Docket No. 50-271
BVY 03-40

Vermont Yankee Nuclear Power Station

Proposed Technical Specification Change No. 259

Instrumentation Technical Specifications

11 X. Turbine stop valve closure

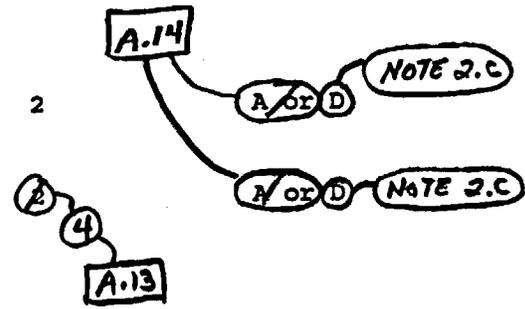
LA.1

A/or/D
NOTE 2.C
A/or/D
NOTE 2.C
